DAIMLER TRUCKS NORTH AMERICA AFTERMARKET

No.: 19TL-8
July 1, 2019

SUBJECT: **Modification to Flywheel TDC Locating Pin Tool – W470589001500**

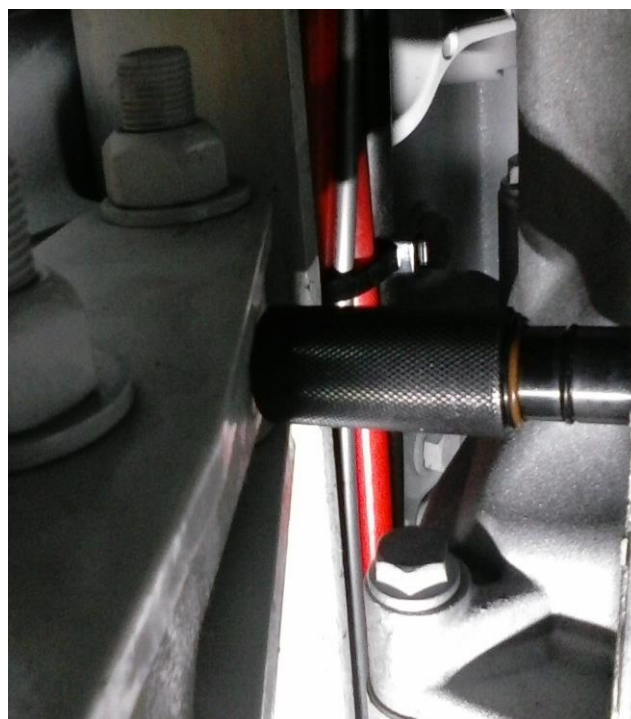
The crossmember mounting bracket of the “New Cascadia” prevents correct installation of the TDC locating pin tool through the crankshaft position sensor hole in the flywheel housing. There is a modification required to the standard tool for it to clear the crossmember mounting bracket in the “New Cascadia” and fit properly into the bore.

Using appropriate equipment, grind the knurled end of the W470589001500 tool to produce a beveled edge. The beveled edge of the flywheel TDC locating pin tool will provide adequate clearance between the crossmember mounting bracket and the flywheel housing.
